KHALSA DESIGN INCORPORATED
Architecture & Urban Planning

RE: Design Review Report for 16-20 Medford Street, Somerville MA

Below is a summary, including images, of the three meetings we had with the Urban Design Commission (UDC) for the proposed project at 16-20 Medford Street.

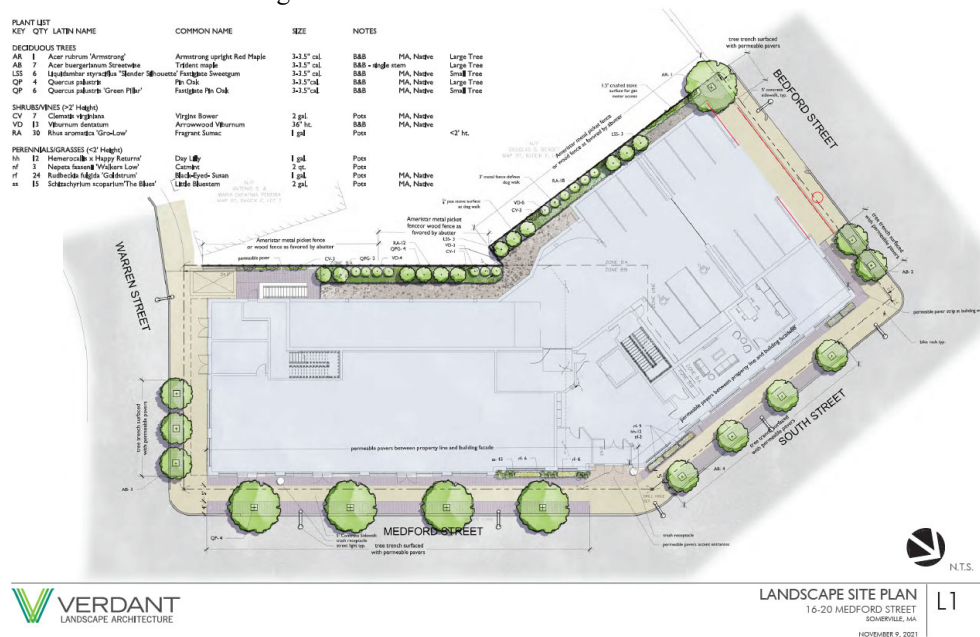
The comments we received from the UDC at this meeting were very constructive. The UDC came to the consensus that they generally prefer Scheme 1 and wanted that further developed. On the South/ Bedford Street sides, they mentioned that they still felt like a horizontal datum was being created at the 2nd floor level. They discussed how they like how they thought the detailing of that area was successful in Scheme 2 and suggested we incorporate that into the design of Scheme 1. They discussed exploring moving the residential lobby. They imposed a design guideline from the ordinance for the center area called “terminating vistas” and wanted the design of that area further studied and treated as a focal point.

They also discussed imposing the design guideline for “building lobbies”. They discussed treating Warren and Bedford Street differently as they are less prominent streets. Discussion was had about refining the sidewalk layout and about the tree layouts/ locations on Warren & Bedford Streets.

The three schemes that we presented at the 2nd UDC meeting addressed the comments received from the UDC at the 1st meeting as well as any further feedback or information received at additional meetings held with city departments. The façade schemes presented were further developed and rendered and each included an exterior materials board as requested. The cornice, “horizontal datum,” at the 2nd floor was removed and the 1st floor pilasters were aligned to correlate with the bay and balconies massing above. The schemes included different ground floor cladding materials and different treatments for the bays and central corner. The Site layout & Landscape Plans were revised to remove the South Street drop-off and equally space the trees along both Medford & South Streets. A dog run was proposed for the rear yard area to create a programmable space for the building’s residents. The paver design was revised for the sidewalk areas.

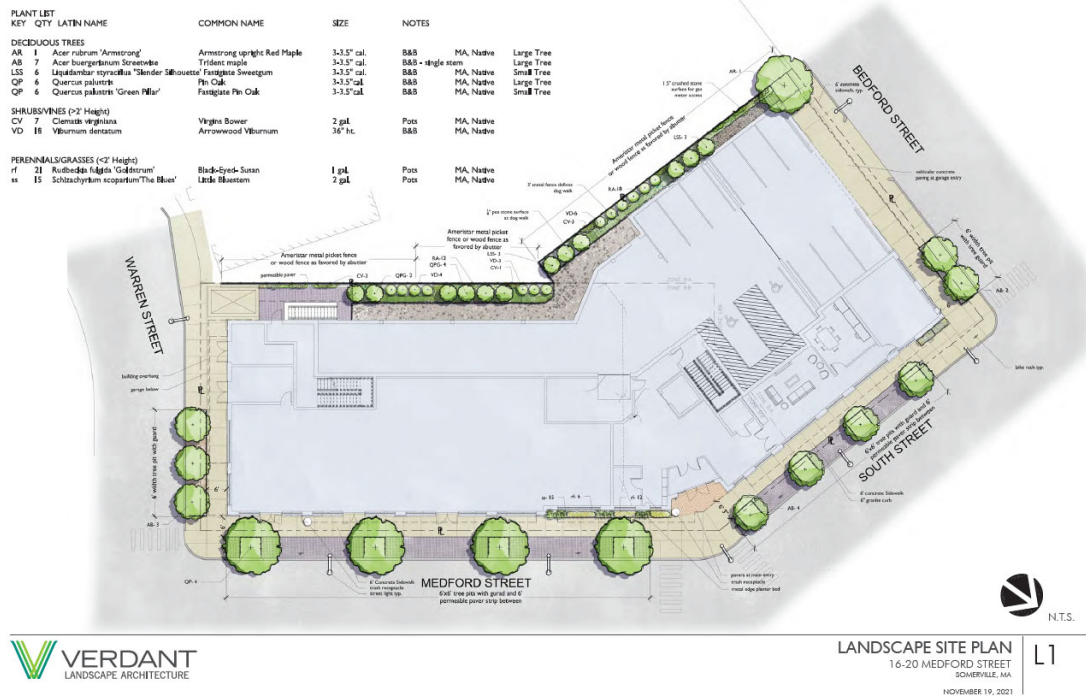
The UDC stated that they greatly appreciated the changes we made and voted unanimously to proceed with their recommendation. They gave their final minor comments which included to confirm the transformer vault cover construction/ consider moving it out of the sidewalk area and extend storefront sill height closer to grade on the commercial space areas to differentiate from the residential 1st floor areas. They asked to see further refinement of the geometry of the wrap around balconies over the central residential entrance as well as the detailing of the central canopy and suggested to remove the 2nd floor cornice at that area. They indicated that reducing bays from 3-story bays to 2-story bays on Warren & Bedford St should be considered. The color/ material of the balcony faces were discussed for "Façade 2" and they asked us to consider another color such as matching the railing color. They also recommended that we add large scale details showing the façade detailing where the building meets grade at sidewalk areas.

On the Landscape design they commented that we should add an additional street tree to Warren Street and move one of the grouped trees on Bedford Street closer towards garage entrance as well as unify the furnishing zone at the corner of Medford & South Streets by extending the pervious pavers at the sidewalk edge. They asked us to further consider an alternative landscape plan for the rear area in lieu of a dog run.

At our final meeting we presented Scheme 1 from the prior meeting but with revisions as requested by the UDC. We incorporated the balcony treatment from the prior Scheme 2. We removed the cornice at the 2nd floor level and reduced the dimension of the balcony floor edge as well as recessed it from the bay wall plane to create a shadow. We addressed the corner of the building at South & Medford Streets to be compliant with SZO "terminating vista" requirements by re-orienting the lobby to be at the corner point and by incorporating the detailing of the prior Scheme 2 central area with modifications, including adding wrap around balconies. This created a focal point to the building. We added a cornice at the 4th floor level on the Bedford Street side to diminish the scale and differentiate the façade. Additionally, we added a wall to shield the parking at Bedford Street.
